ADDENDUM NO. 3

Project Name: Building Renovation for Haverford Township Free Library
Project No.: 7010.03-22
Date of Issue: October 10, 2023
Notice 1: Attach this addendum to the Project Manual for this project. It modifies and becomes part of the Bidding Documents. Work or material not specifically mentioned herein is to be as described in the main body of the Project Manual, and as shown on the drawings.

BASEMENT DEMO FLOOR PLAN - MECH/PLUMB/ELECT
SCALE: 1/8"=1'-0"

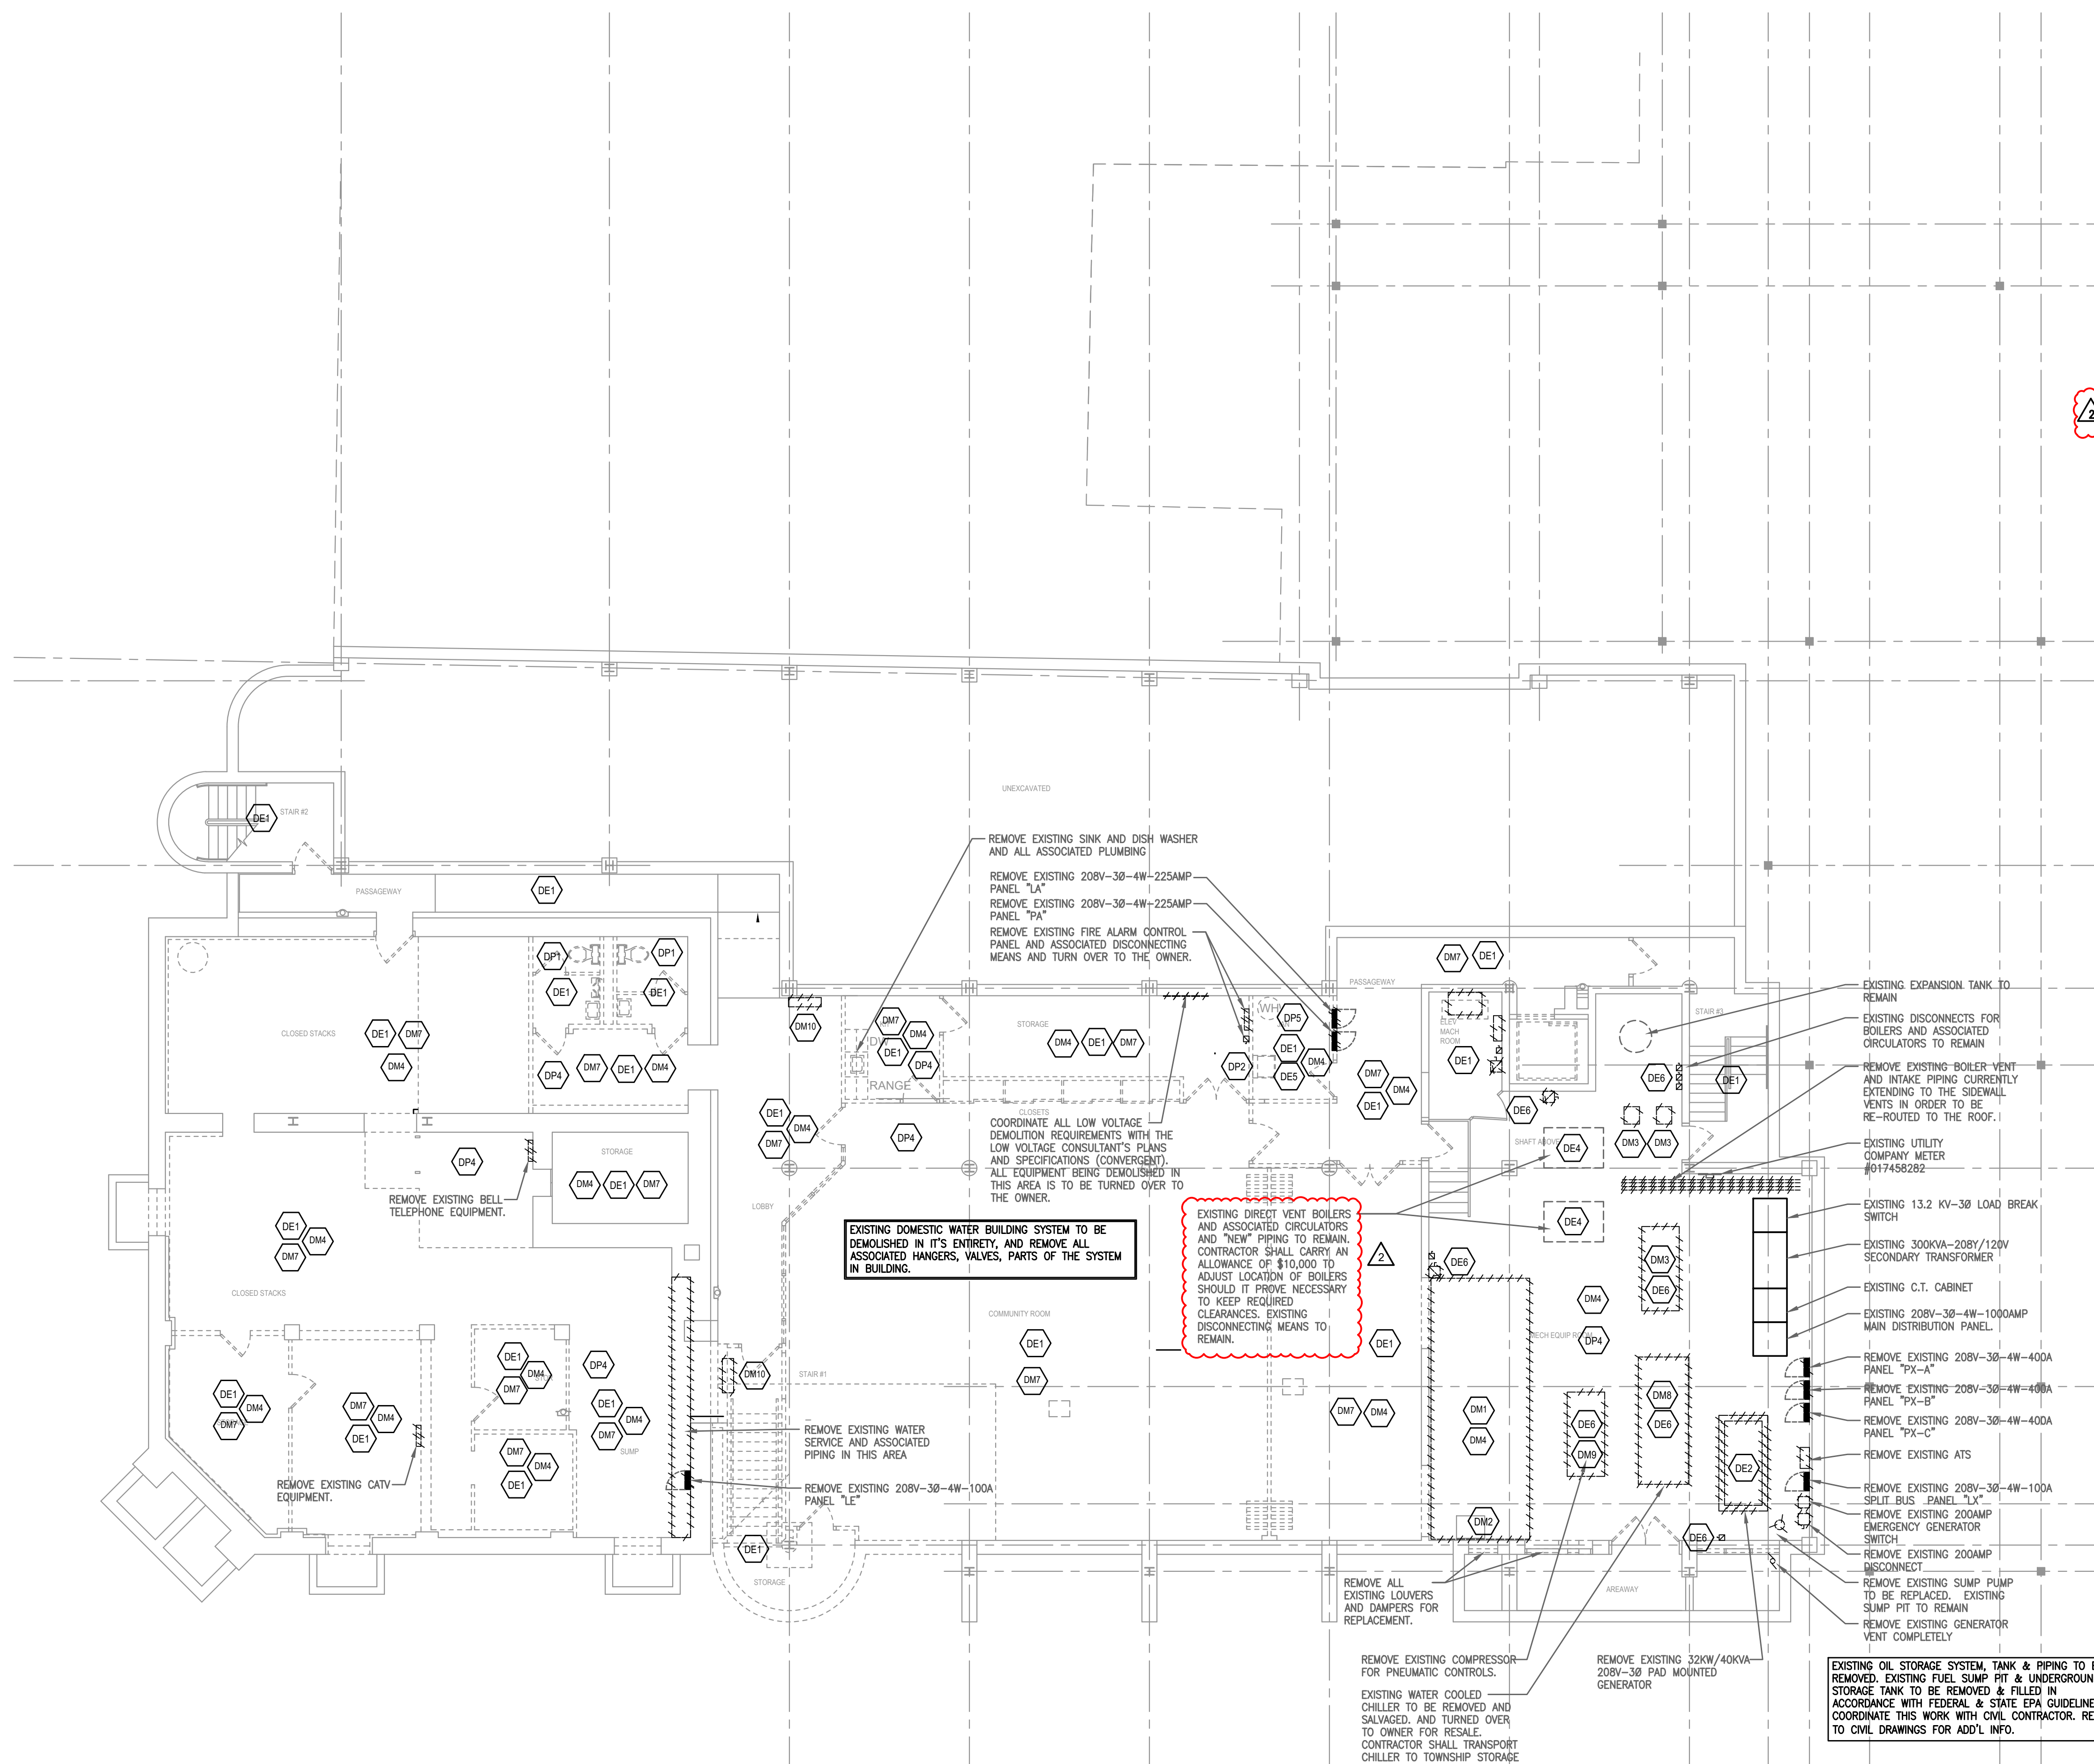
6. On Sheet **S1.3**, add Note 21. The revised sheet is attached as part of this addendum.
7. On Sheet **DMPE1.0**, revise Mechanical Demolition Notes, Plumbing Demolition Keynotes, Electrical Demolition Keynotes, and Electrical Demolition Notes as indicated. The revised sheet is attached as part of this addendum.

FIRST FLOOR DEMO PLAN - MECH/PLUMB/ELECT
SCALE: 1/8"=1'-0"

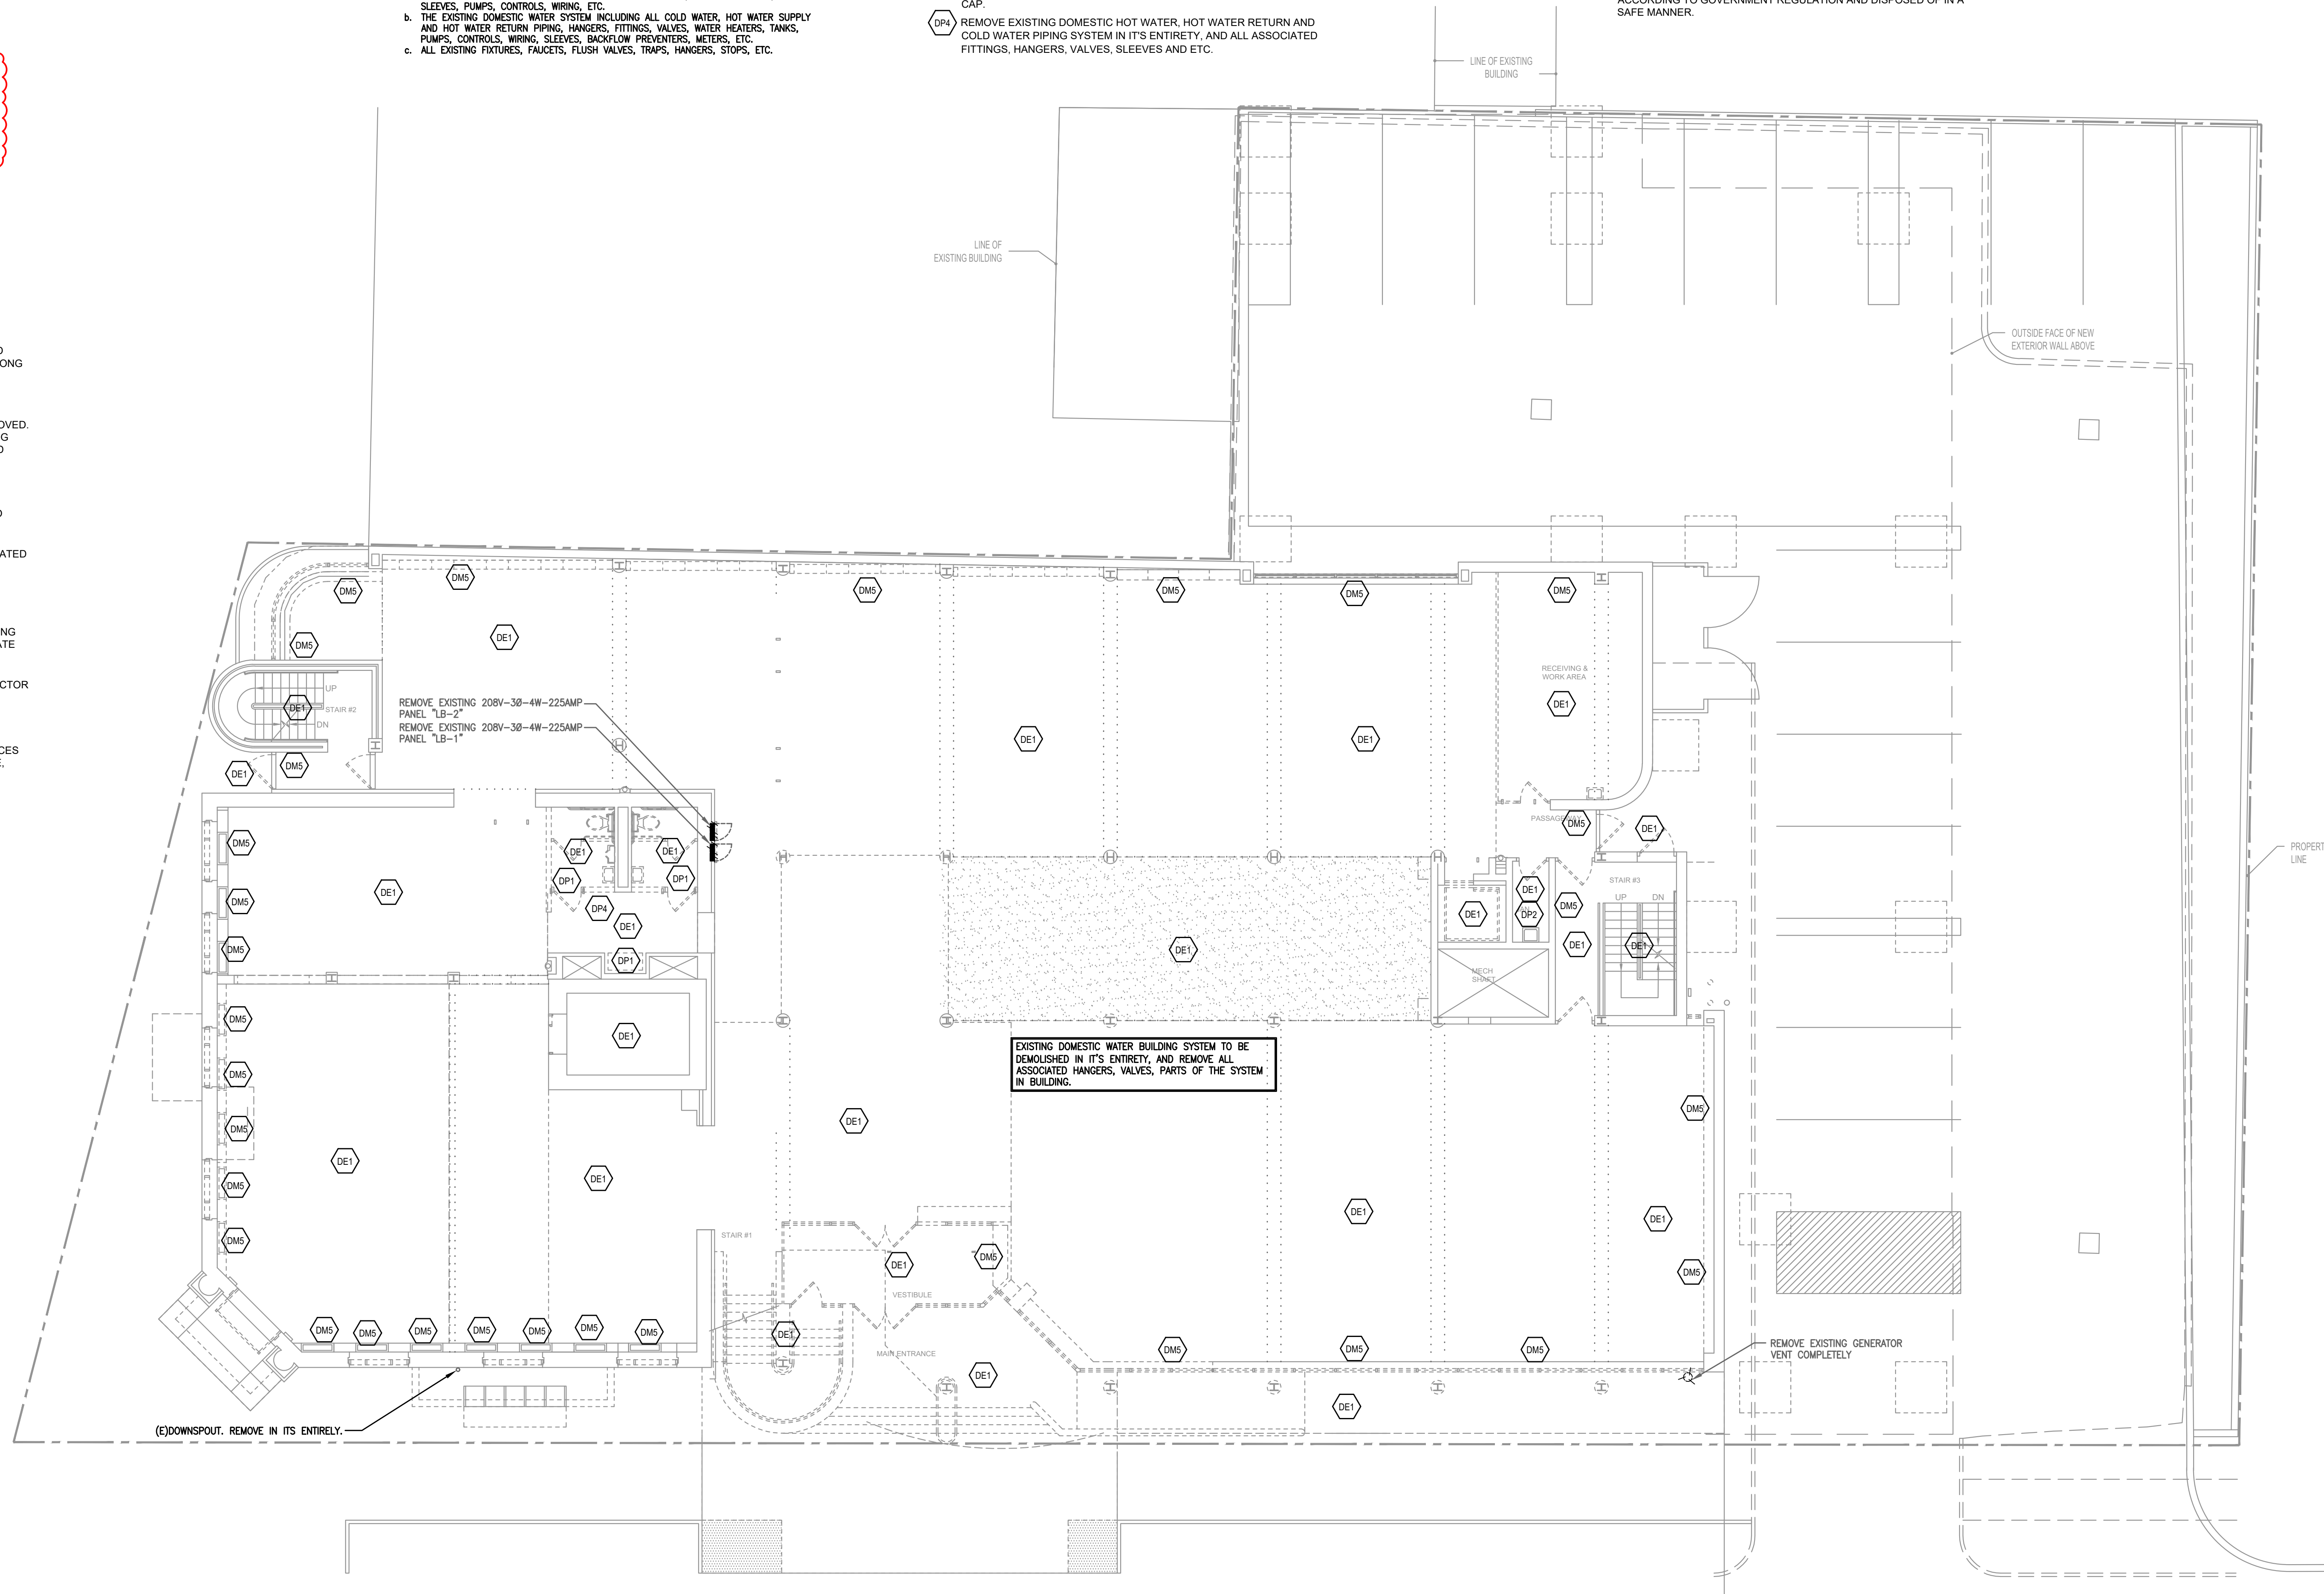
8. On Sheet **DMPE1.1**, revise Mechanical Demolition Notes and Plumbing Demolition Keynotes, as indicated. The revised sheet is attached as part of this addendum.

SECOND FLOOR DEMO PLAN - MECH/PLUMB/ELECT
SCALE: 1/8"=1'-0"

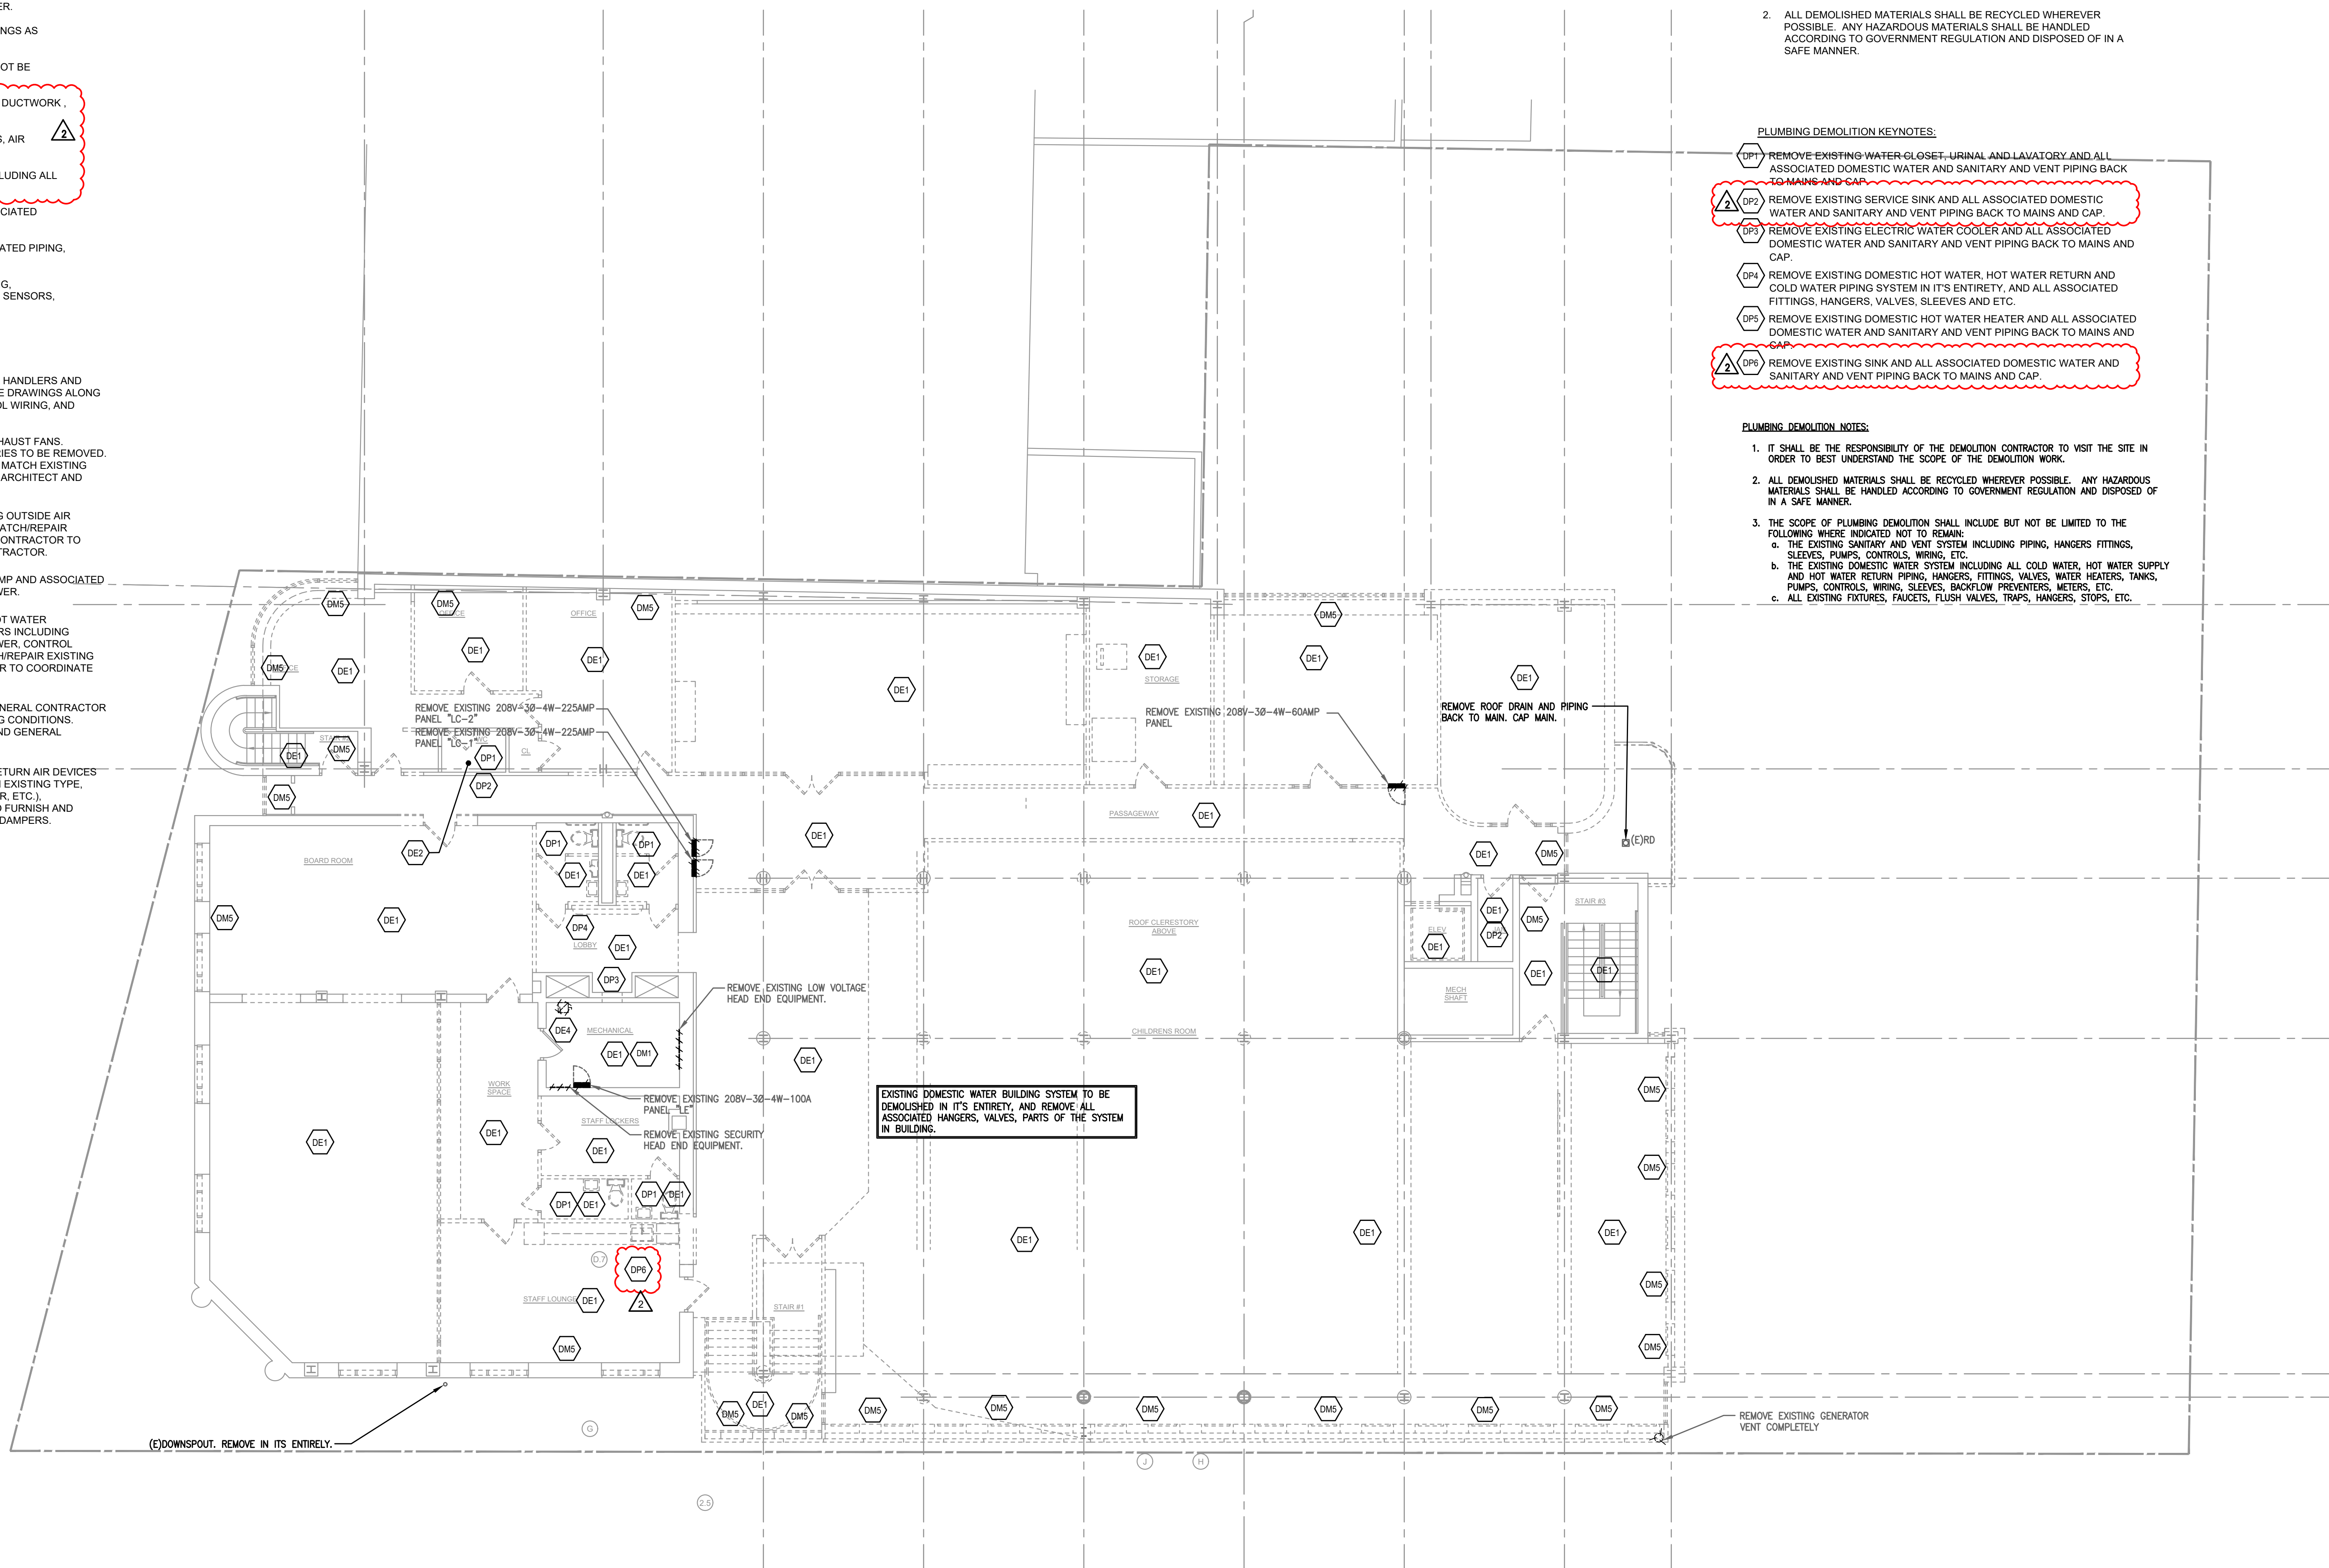
9. On Sheet **DMPE1.2**, revise Mechanical Demolition Notes and Plumbing Demolition Keynotes, as indicated. The revised sheet is attached as part of this addendum.
